SUNDRY NOTICES AND REPORTS ON WELLS
Do not use this form for proposals to drill or to re-enter an abandoned well. Use form 3160-3 (APD) for such proposals.

| 3b. Phone No. (include area code) Ph: 432-687-7375 | | 8. Well Name and No. CO YETI 15 22 FED COM 0052H |

This sundry is to clarify the original COA's regarding pressure control equipment. The 5M BOP will be utilized on these wells after the surface shoe, and the 10M BOP (that is already included in the COAs) will be utilized after the intermediate shoe and therefore used for the production hole section accordingly.

**PECOS DISTRICT
DRILLING CONDITIONS OF APPROVAL**

BLOWOUT PREVENTER SCHEMATIC

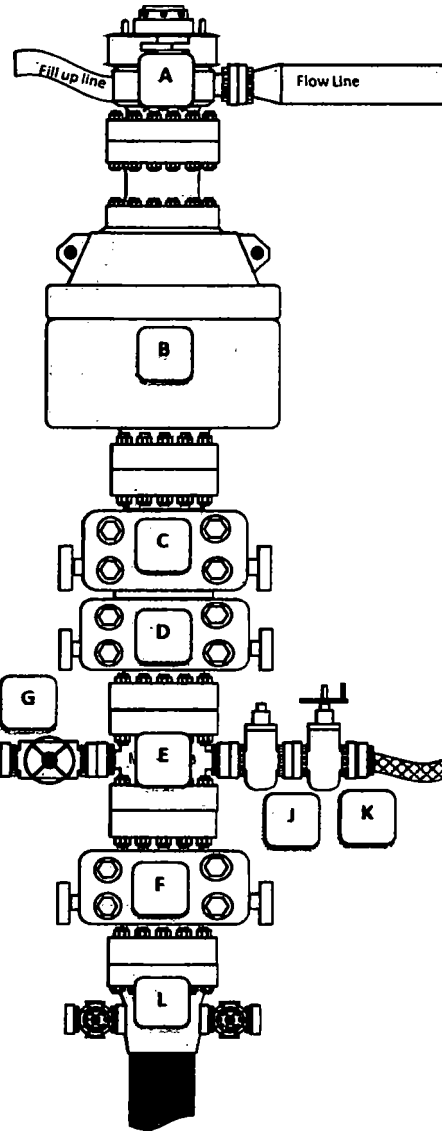
See attached 5M Intermediate BOP and choke manifold

- a. Minimum working pressure of the blowout preventer (BOP) and related equipment (BOPE) required for drilling below the surface casing shoe shall be **5000 (5M)** psi.
- b. Minimum working pressure of the blowout preventer (BOP) and related equipment (BOPE) required for drilling below the intermediate casing shoe shall be **10,000 (10M)** psi.
